DESIGN CHANGE NOTICE – CHANGE ORDER No. 001

Kanaka Creek Road Improvements

Date: August 21, 2017
 Federal Aid: TA5527
 State Contract: N/A
 Contract: _____
 Projects: Kanaka Creek Road Improvements
 Change Order: 001

Reason for Change:

CITY OF STEVENSON
KANAKA CREEK ROAD IMPROVEMENTS
ROAD TYPICAL SECTIONS

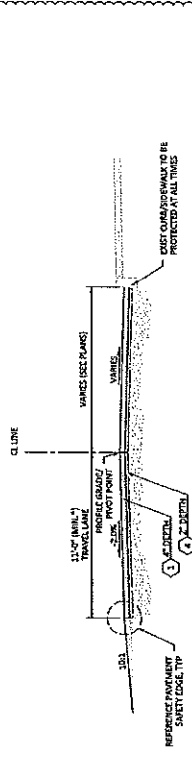
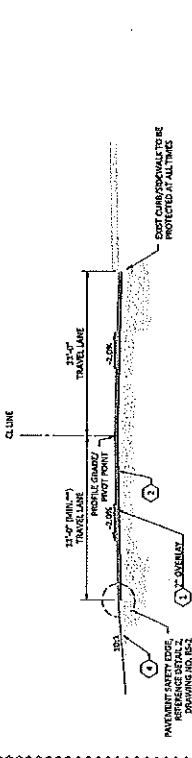
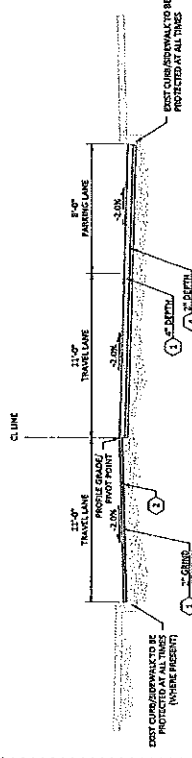
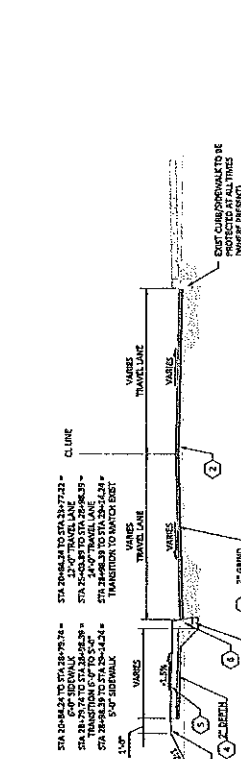
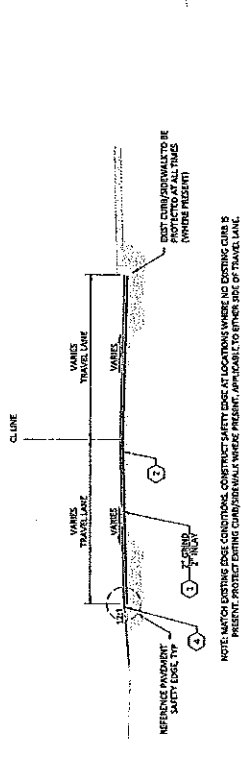
STA 13+25 to 17+25 (approx.): additional work includes pavement grind and inlay and roadway excavation within the existing road shoulder (eastbound travel lane) to match road into the adjacent sidewalk construction project. Original contract included an overlay. Additional work includes roadway excavation and construction within the existing road shoulders for the realigned roadway. Additional quantities of planing, road excavation, CSBC and HMA are included in this stationing of work.

STA 17+25 to 19+80 (approx.): additional work includes roadway excavation within the existing road and road shoulder (eastbound travel lane) to match road into the adjacent sidewalk construction project. Original contract included a grind and inlay. The additional roadway excavation is required due to the adjacent sidewalk project lowering of sidewalk grades to meet ADA requirements for a sidewalk ramp landing at the school's entrance. Additional quantities of road excavation, CSBC and HMA are included in this stationing of work to rebuild the road section.

STA 13+25.00 TO STA 13+25.25
* CONSTRUCT 11'-0" TRAVEL LANE OR MATCH EXISTING EDGE OF PAVEMENT (WHICHEVER IS GREATER)

STA 14+02.00 TO STA 14+12.75
* CONSTRUCT 11'-0" TRAVEL LANE OR MATCH EXISTING EDGE OF PAVEMENT (WHICHEVER IS GREATER)

STA 14+65.25 TO STA 15+13.25
* BUT, PROTECT EXISTING CURB OR MATCH EXISTING EDGE OF PAVEMENT (WHICHEVER IS GREATER)

CITY OF STEVENSON
KANAKA CREEK ROAD IMPROVEMENTS
GROPPER ROAD PLAN AND PROFILE
STA 17+50 TO STA 22+50

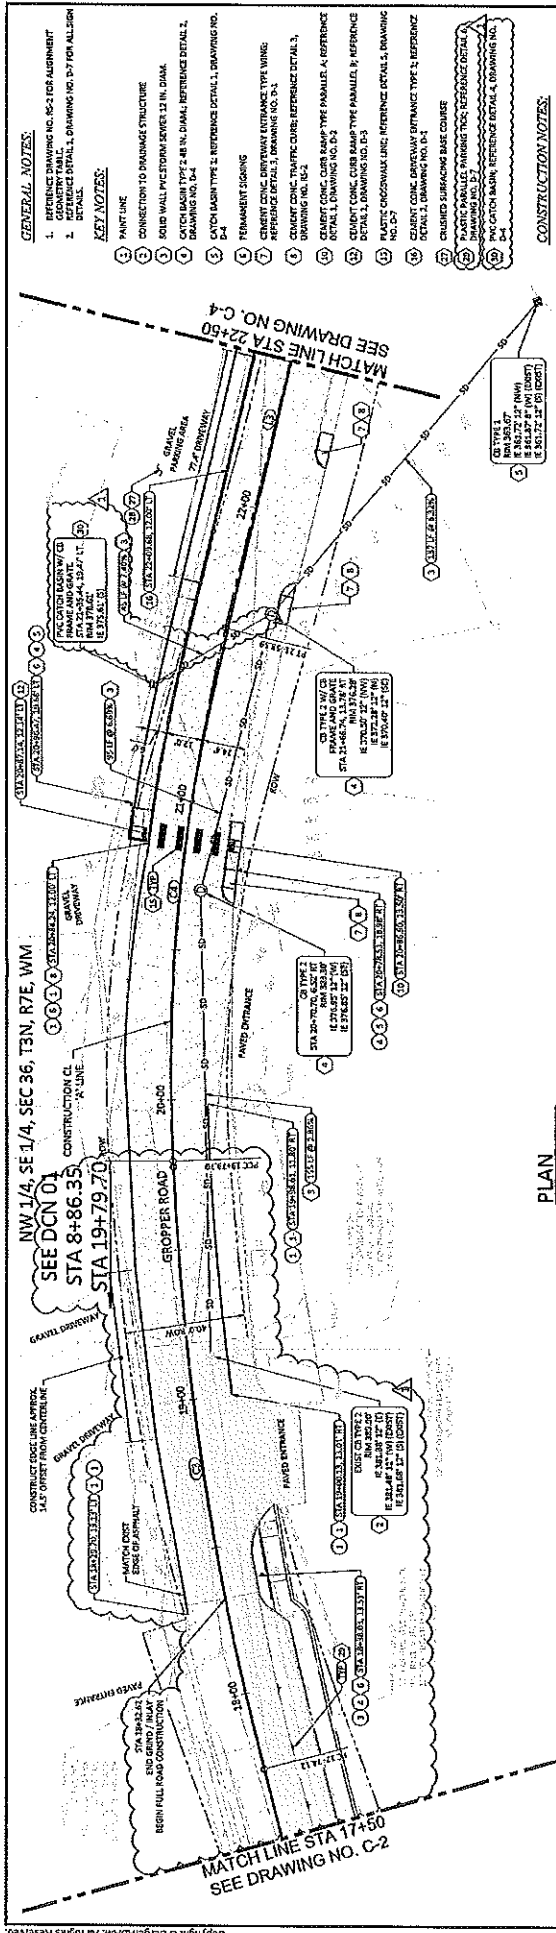
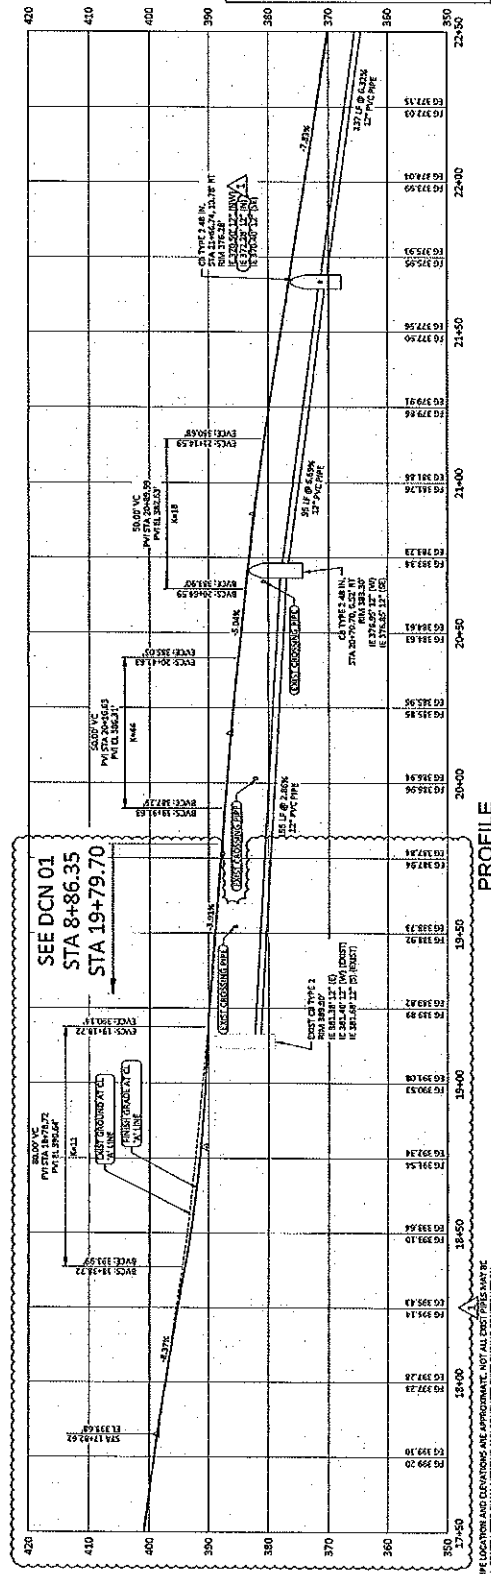
At STA 21+35: additional work includes replacing an existing drainage structure at back of proposed sidewalk not found on the survey. Includes reconstructing of the pipe conveyance from this structure as well.
